SERVICE BULLETIN

APPLICABILITY: 2013-14MY BRZ

NUMBER: 12-162-14

SUBJECT: Design Change to Rear Combination Lamps to Prevent Insect Intrusion

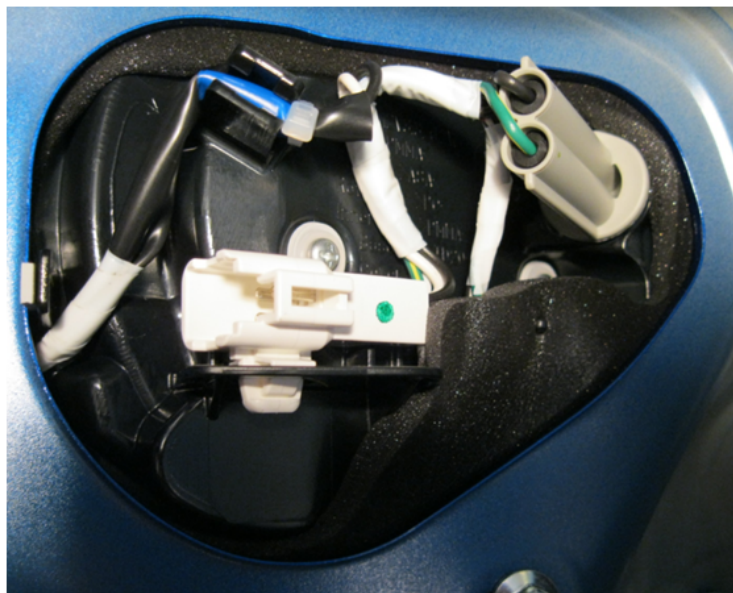
- Peel the tape backing of the new gaskets to expose the adhesive then install the gasket down over the mounting studs. Position the revised shape area and adhesive of the gasket over the additional ribbing and align the edge with the white harness connector as shown in the photos below (right side lamp shown).

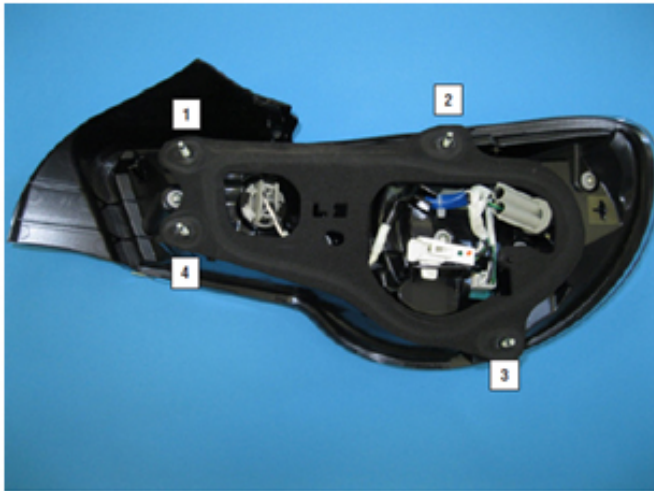
- Refit the combination lamp assemblies to the vehicle but before tightening the retaining nuts, confirm the new gaskets are in the proper position as shown in the photo below (left side shown).

L/H Sequence

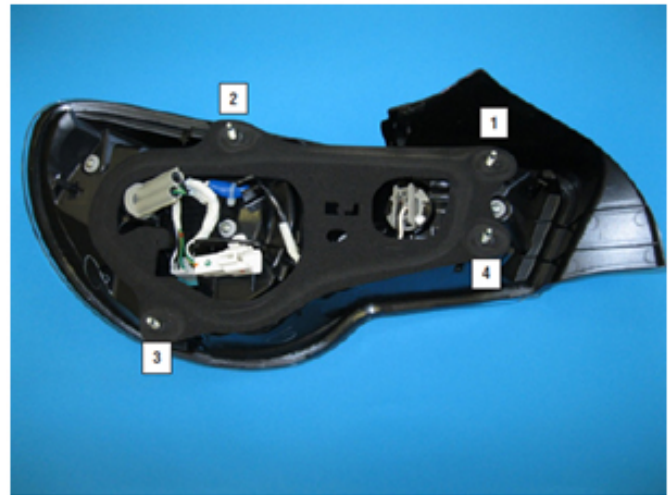
- The proper torque sequence must be followed as shown in the following illustrations or damage to the combination lamp assembly may result. The torque specification for the retaining nuts is 4.5 Nm (39 inch-pounds).
